Subject: EPA Comments on Dynegy Midwest Generation Inc. – Hennepin Power Station, Hennepin, IL  
Round 10 Draft Assessment Report

**RE: DMG Comments on Draft Assessment of Dam Safety of Coal Combustion Surface Impoundments at the Hennepin Power Station, dated March 15, 2012**

P2-1 - Circular Failure, Seismic.slim

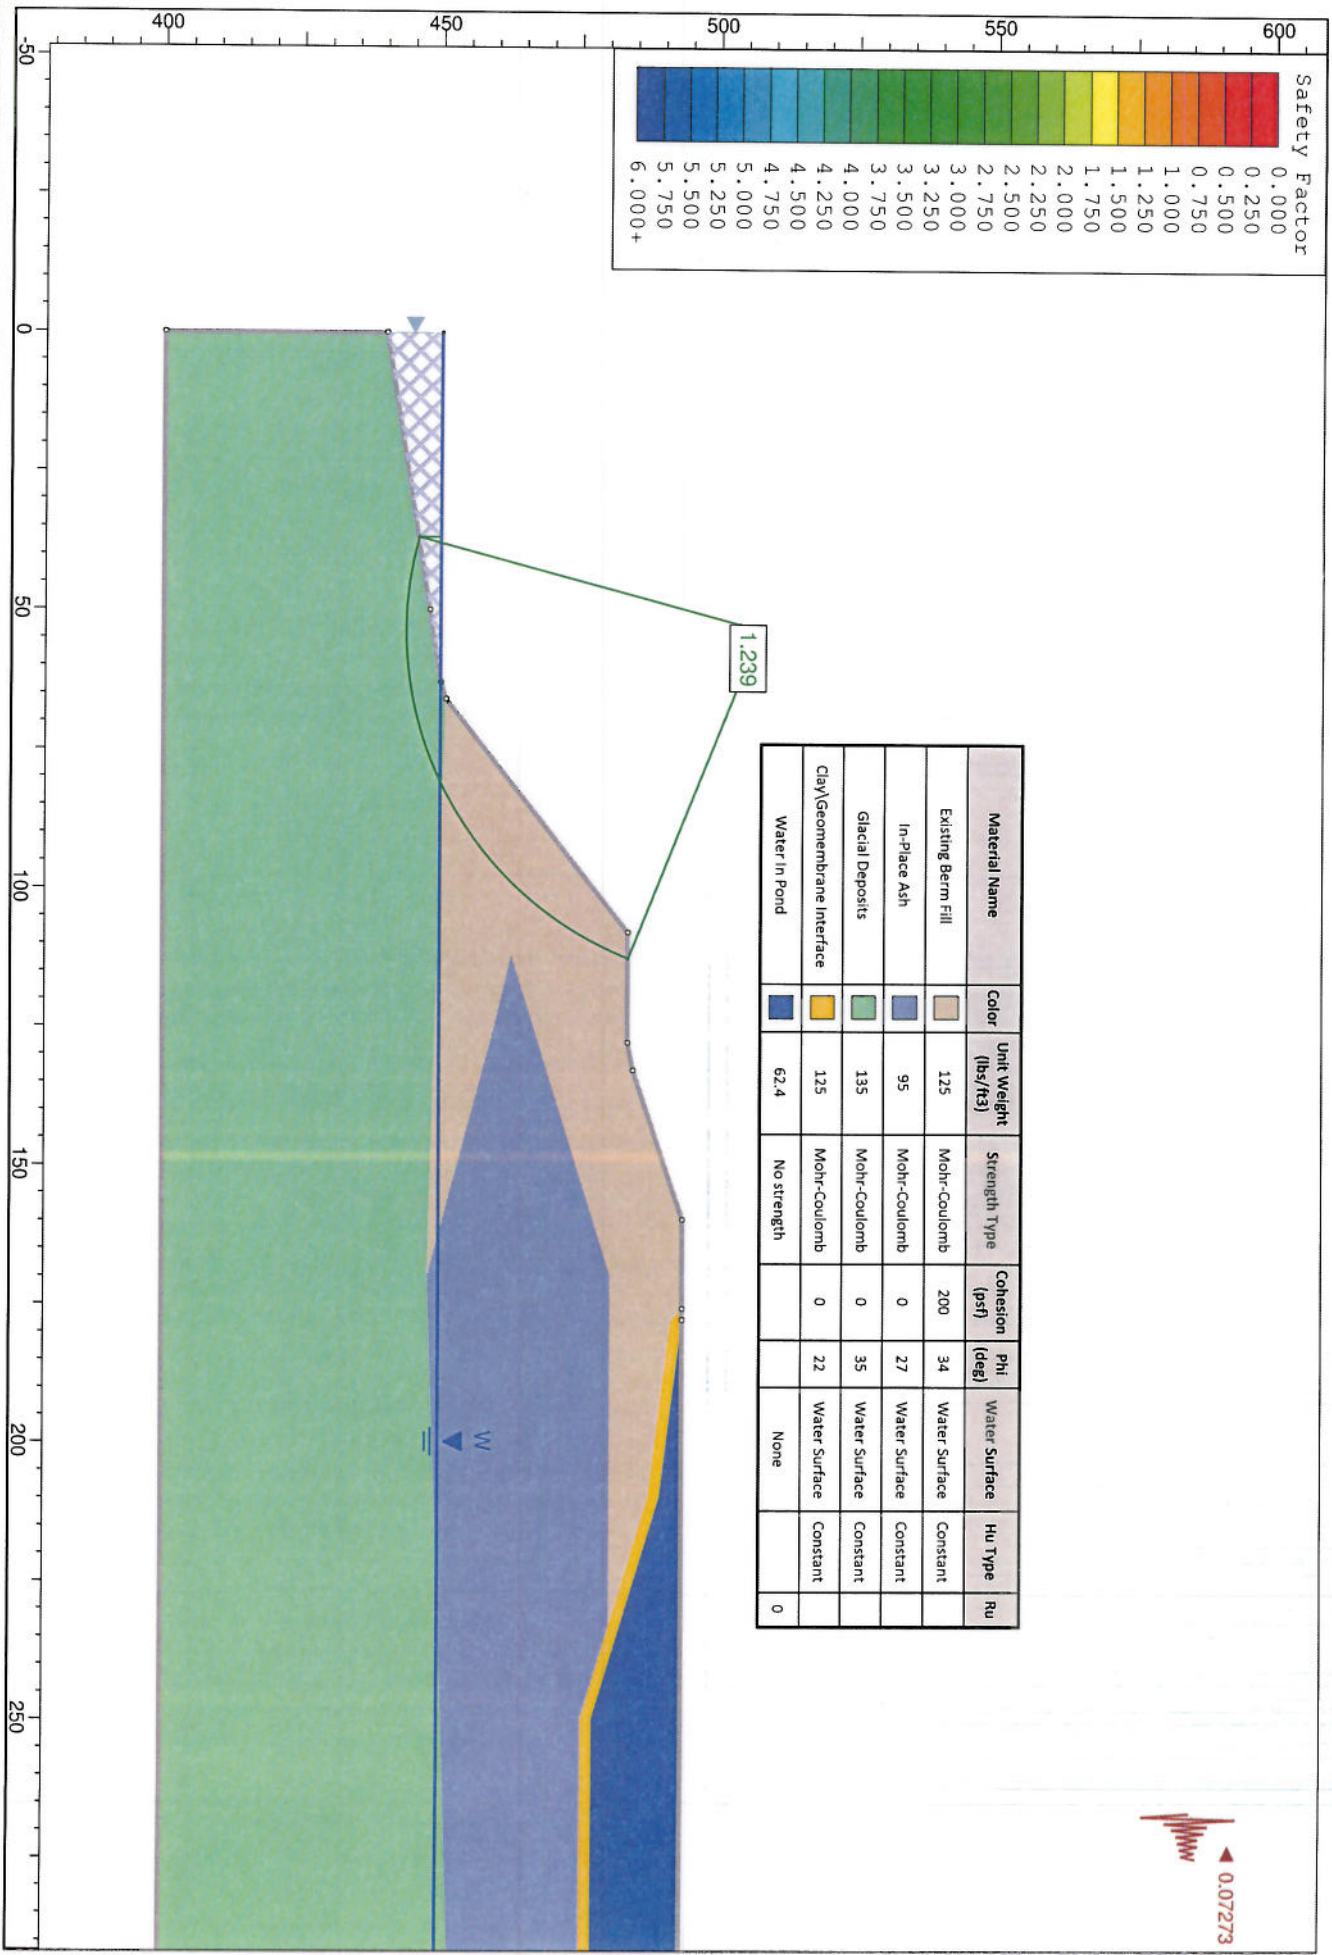
As part of the analysis, slope stability was also performed on the existing slope along the Illinois River in the vicinity of the proposed landfill and Pond 2E. As commented by GZA, the minimum static condition FS's calculated for these conditions were 1.19 and 1.01 for NB-2 and P2-1, respectively. The seismic (pseudo-static) analyses presented minimum FS's of 1.13 and 0.95 for NB-2 and P2-1, respectively. However, the intent of this analysis was not to provide a detailed analysis of the existing embankment, but to conservatively back-calculate the embankment material's soil parameters to use in the deep-seated analysis of the landfill.

CEC performed a revised stability analysis for Section P2-1 utilizing more realistic effective shear strength parameters for the existing berm fill ( $\Phi' = 34^\circ$ ,  $c' = 300$  psf). These parameters are more consistent with the conditions encountered in the test borings at the site. Utilizing these parameters yields a FS = 1.37 and 1.24 for static and seismic conditions, respectively (see attached stability analyses).

DMG/CEC conclude that the northern embankments along the Illinois River adjacent to the EAPS are adequately stable. This conclusion is based on the following:
